# UNITED STATES PATENT AND TRADEMARK OFFICE

APPLICATION NO.	FILING DATE	FIRST NAMED INVENTOR	ATTORNEY DOCKET NO.	CONFIRMATION NO.
10/517,735	08/08/2005	Ian Richard Webb	R&G C-388	5929
23474 7590 04/06/2007 FLYNN THIEL BOUTELL & TANIS, P.C. 2026 RAMBLING ROAD KALAMAZOO, MI 49008-1631			EXAMINER RIPLEY, JAY R	
			ART UNIT	PAPER NUMBER
			3679

**Office Action Summary**

## **DETAILED ACTION**

(Straub Figures 1-5)

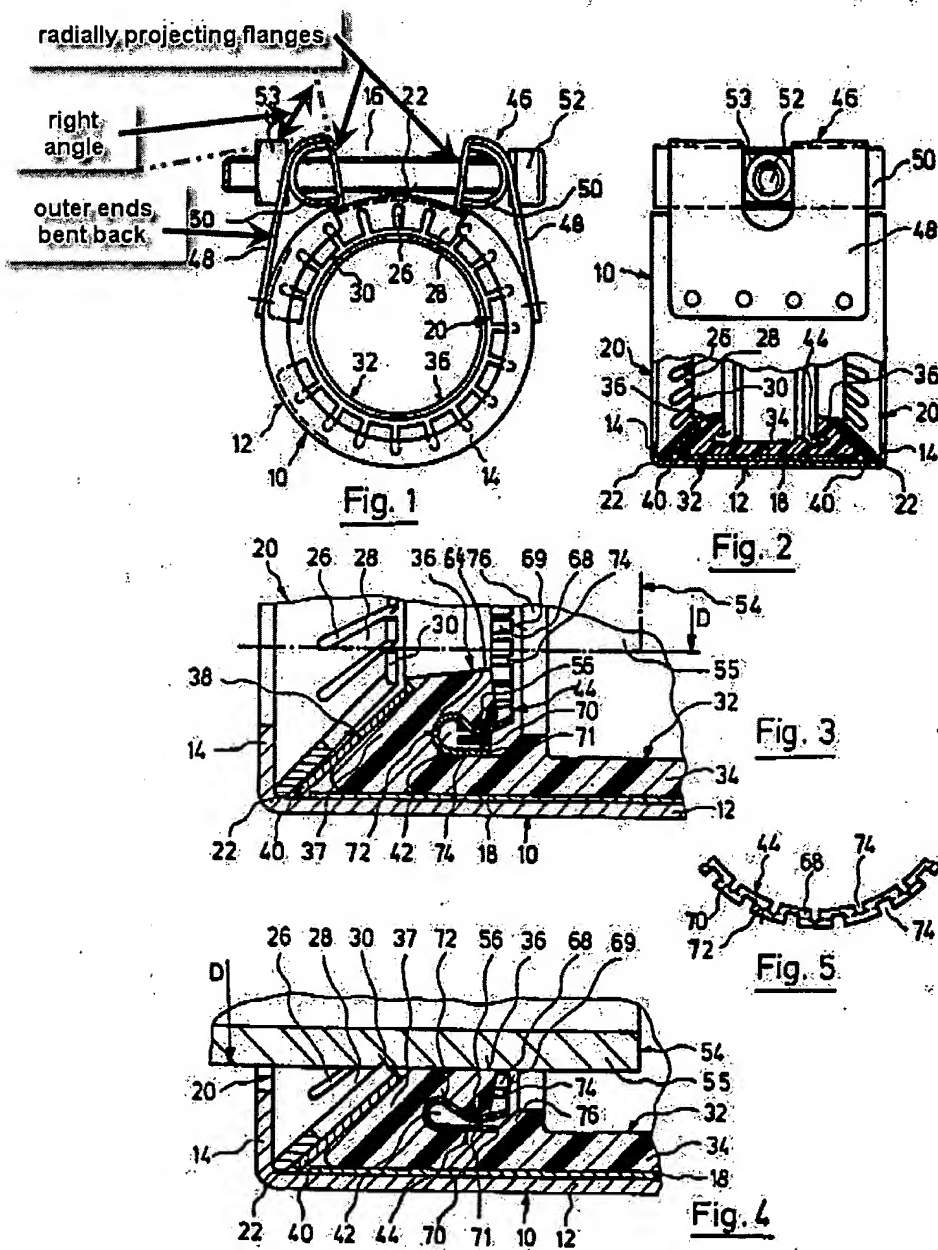
18. In regard to claim 10, Straub, in Figures 1-5, below, discloses a pipe coupling for connecting together the ends of two pipes, comprising:

a tubular casing (10) having circumferentially extending end flanges (14) projecting inwardly from the axial ends of the casing,

a tubular sealing sleeve (32) inside the casing;

tensioning (52 and 53) means for tightening the casing around the sealing sleeve; and

frusto-conical gripping rings (44) located within the casing at opposite ends of the casing, the inner edges of the gripping rings being formed with teeth (68);

the casing comprising a strip of metal formed into a tube with a gap (as observed in Figure 1) extending longitudinally of the casing between the free ends of the strip;

20. In regard to claim 16, Straub further discloses that the aligned holes are elongated in the radial direction (as observed in Figure 2).
21. In regard to claim 17, Straub further discloses a backing ring (40 in Figure 3, above) is provided inside the casing adjacent each gripping ring (44) between the gripping ring and the sealing sleeve (32) to prevent the sealing sleeve bulging between the teeth of the gripping ring.

22. In regard to claim 19, Straub further discloses that the outer ends of the radially projecting flanges are bent back to form stiffening flanges (as observed in Figure 1, above) along the longitudinal outer edges of the radially projecting flanges.

23. In regard to claim 20, Straub further discloses that the radially projecting flanges are bent back at right angles (as observed in Figure 1, above).

(Straub Figure 1 cutout)

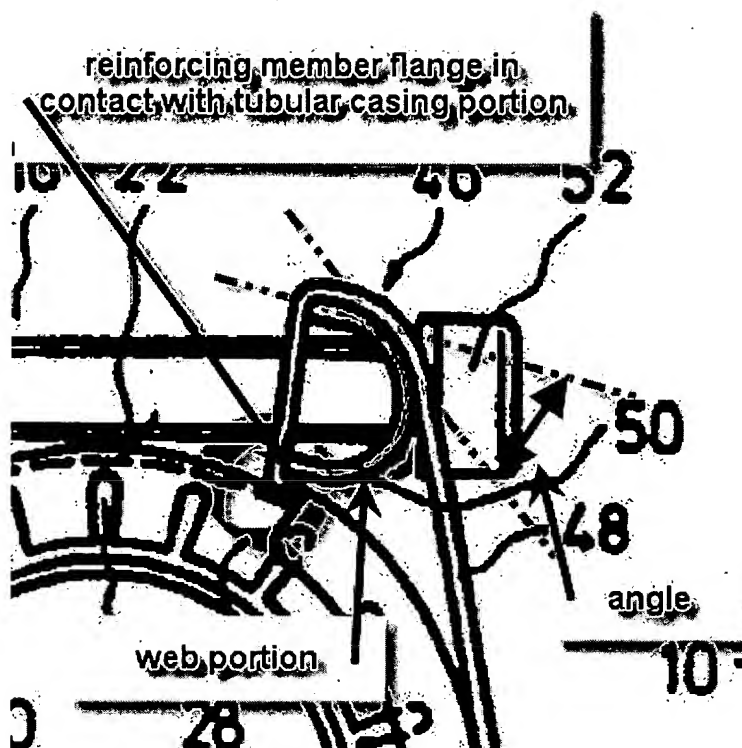
holes in the reinforcing members and the radially projecting flanges, the reinforcing members each having an angled cross-section (the reinforcing members are U-shaped [column 3, lines 8-9] and, therefore, there is an angle formed by the junction of the straight sides and the curved portion as shown in Figure 1 cutout, below) of the , a web portion (shaded in Figure 1 cutout, below) through which the holes for the tensioning means pass, and a flange running along the longitudinal edge of the web portion that is nearer to the axis of the coupling, the flange of the reinforcing member bearing against the tubular portion of the casing.

19. In regard to claim 11, Straub further discloses that each reinforcing member has a channel-shaped cross section with flanges (the straight sides of the U-shape) running along both longitudinal edges of the web portion (as observed in Figure 1 cutout, above).
